UNITED STATES PATENT AND TRADEMARK OFFICE

Office Action Summary	Application No.	Applicant(s)
	10/665,450	HARADA ET AL.
	Examiner	Art Unit
	Marissa L. Ferguson-Samreth	2854

DETAILED ACTION

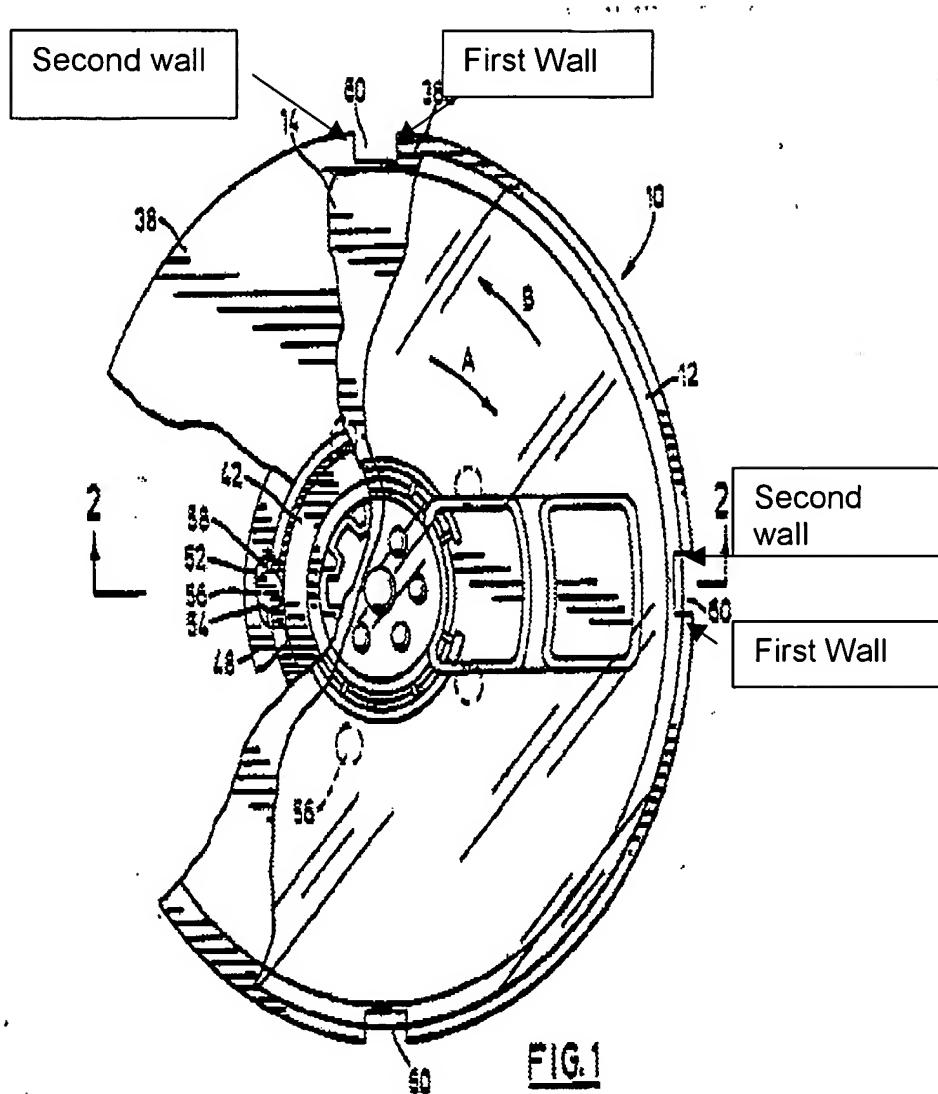
Regarding claim 1, Armstrong et al. teaches a ribbon supply spool (66), a ribbon take up spool (10) that takes up an ink ribbon from said ribbon supply spool by rotating in a first rotation direction, said ribbon take up spool being provided with an engaging portion (60), an engaging member (80,130,222,230) that resiliently engages with said engaging portion to prevent said ribbon take up spool from rotating in a second rotation direction opposite to said first rotation direction, said engaging member coming off from said engaging portion when said ribbon take up spool rotates in said first direction (Abstract) and wherein said engaging portion (60,200) includes a first and second walls (refer to figure below) said take-up spool being prevented from rotating in said second direction as said engaging member engages with the first wall and said take-up spool being allowed to rotate in said first direction as said engaging member slips on the second wall (Abstract).

Regarding claim 2, Armstrong et al. teaches wherein said engaging portion (60,200) includes first and second walls arranged in said second rotation direction in this order, said engaging member (80,130,222,230) engaging with said engaging portion (60,200) by dropping into a space defined between said first and second walls (Figure 3), said first wall being defined along a plane including a rotation axis of said ribbon take up spool.

Regarding claim 3, Armstrong et al. teaches wherein said second wall is formed so as to allow said engaging member (80,130,222,230) to come off from said engaging portion (60,200) by sliding (elements 80 and 222 have a slanted tip which in turn causes the sliding movement) along said second wall when said ribbon take up spool is rotated in said first rotation direction.

Regarding claim 4, Armstrong et al. teaches wherein said second wall is inclined to face outside said ribbon take up spool (Figures 1 and 3).

Also, as indicated in the previous arguments, the engaging will also lock in notch 60 if the spool is in the proper locking location and will unlock if the notch 60 is not properly aligned. The unlocking causes the spool to slip on the second wall as indicated in the figure 1 as located on page 2 of this action and will allow the spool to rotate (Abstract, Column 1, Lines 16-34, Column 2, Lines 55-58 and Column 3, Lines 1-30).
